MINUTES OF MEETING
OF
THE 3rd MISSION OF THE PREPARATORY STUDY
FOR DEVELOPMENT OF SOUTHERN LARGE SCALE
THERMAL POWER PLANT IN IRAQ

AGREED UPON BETWEEN
MINISTRY OF ELECTRICITY OF IRAQ
AND
THE STUDY TEAM OF
JAPAN INTERNATIONAL COOPERATION AGENCY

AMMAN, 27TH-30TH NOVEMBER, 2011

400KV CABLE ROUTE PLAN

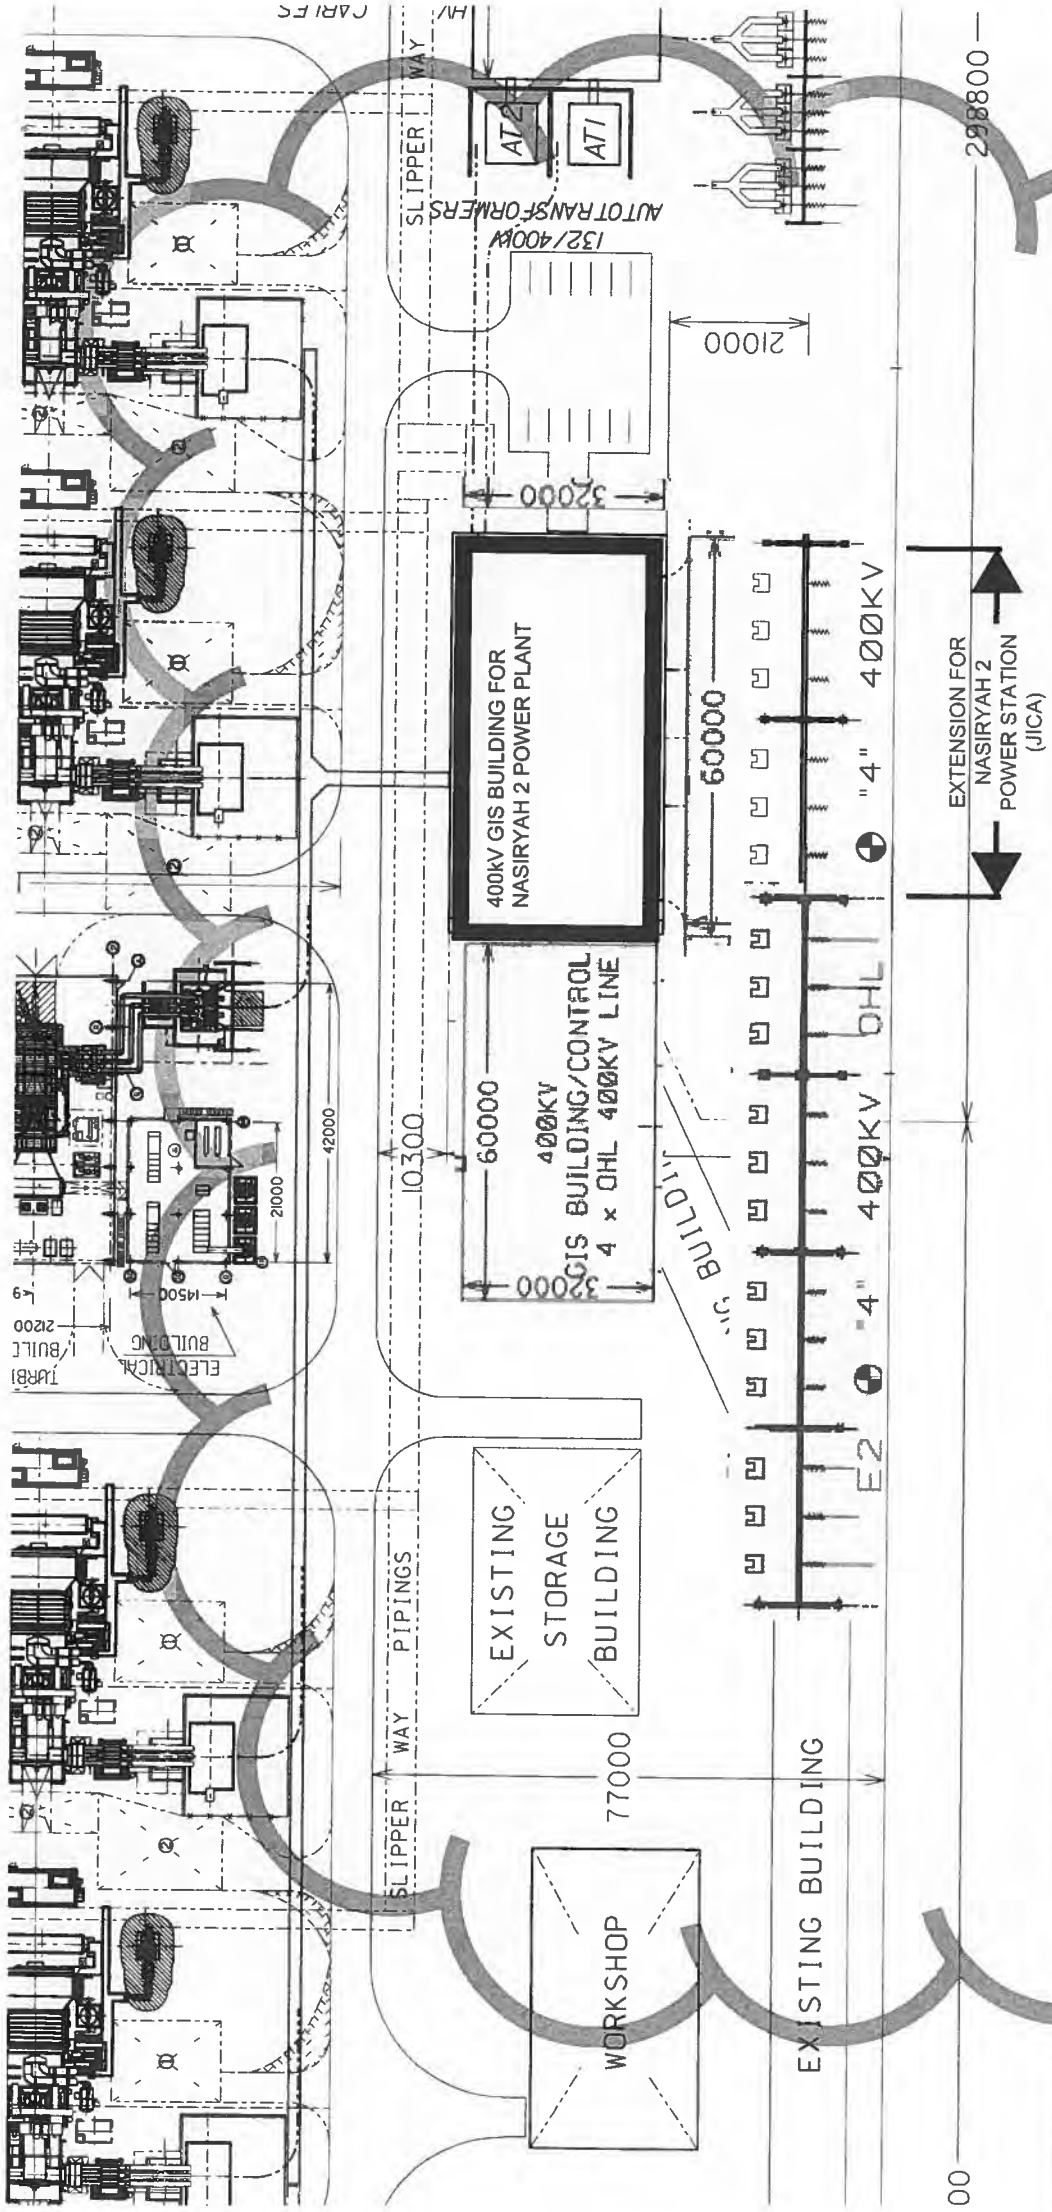
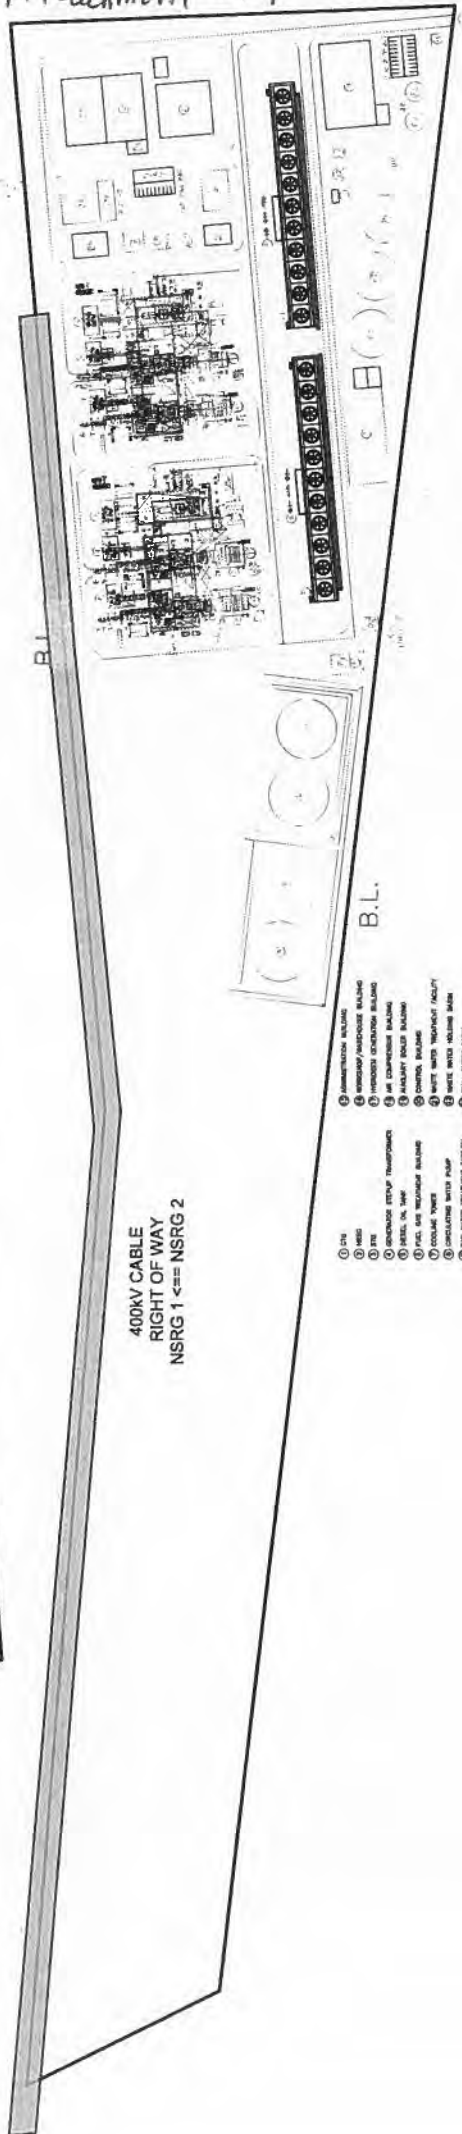
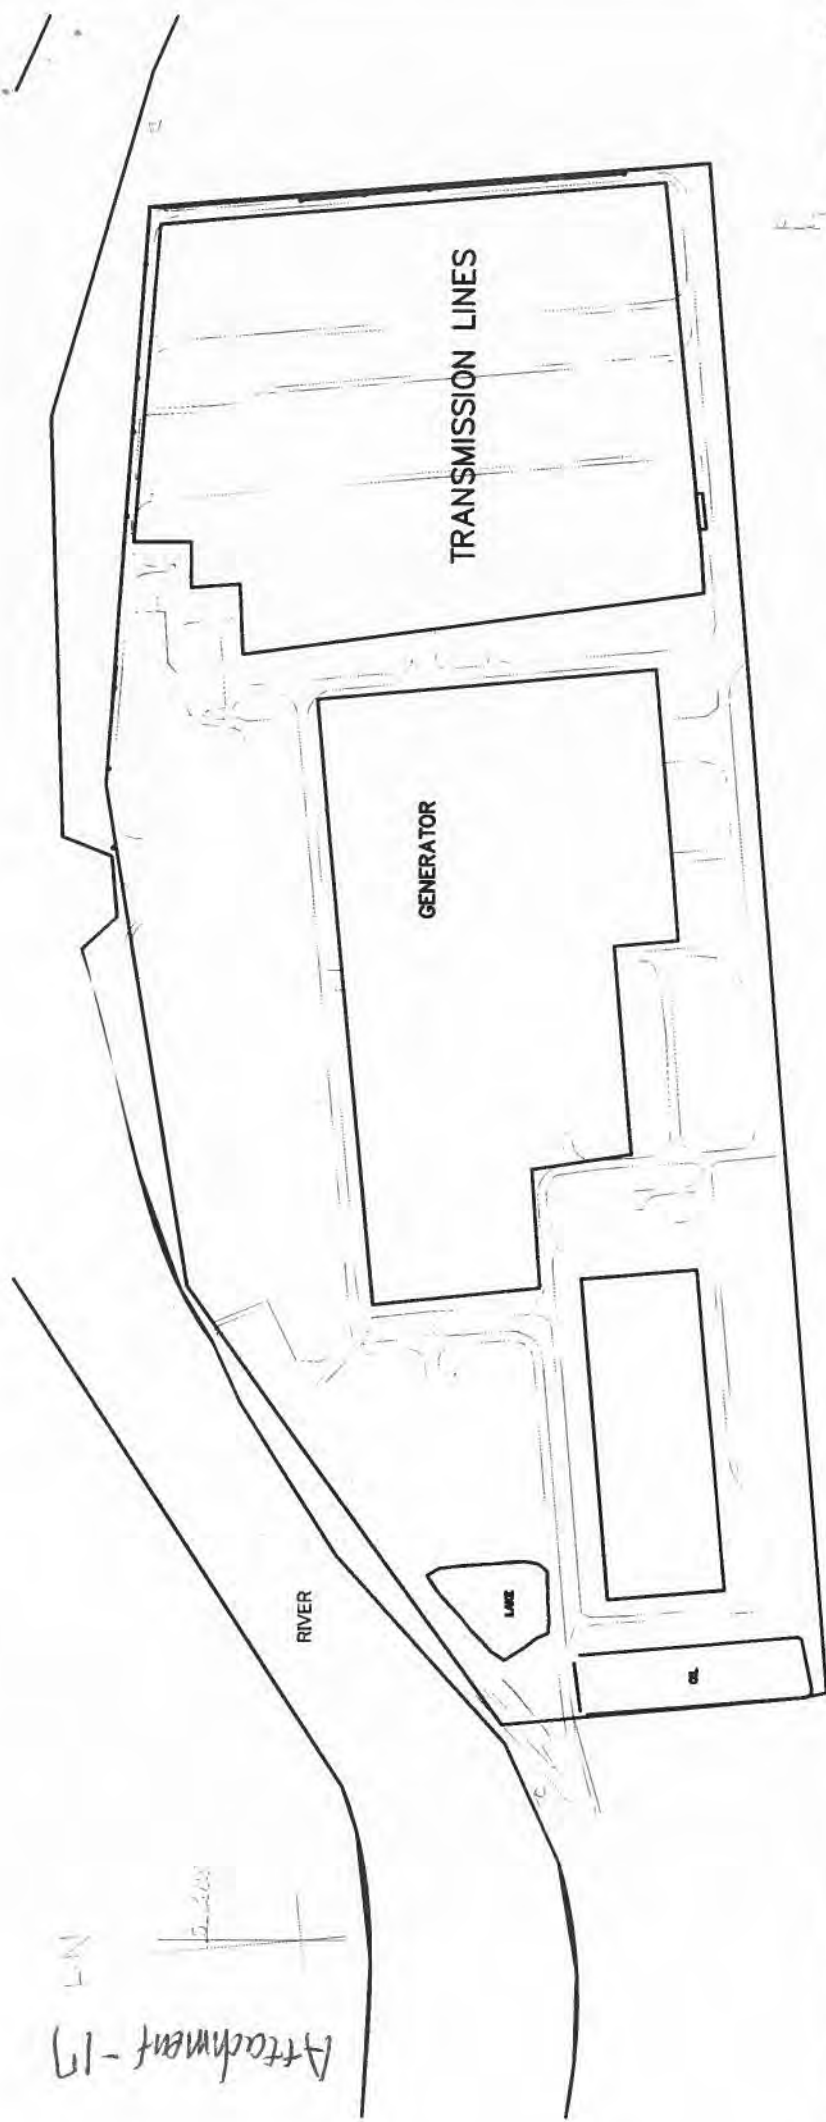
The proposed 400kV Cable Route is underground concrete cable trench along the battery limit as shown on Attachment-17 and Attachment-18. MOE Team has no objection to this philosophy.
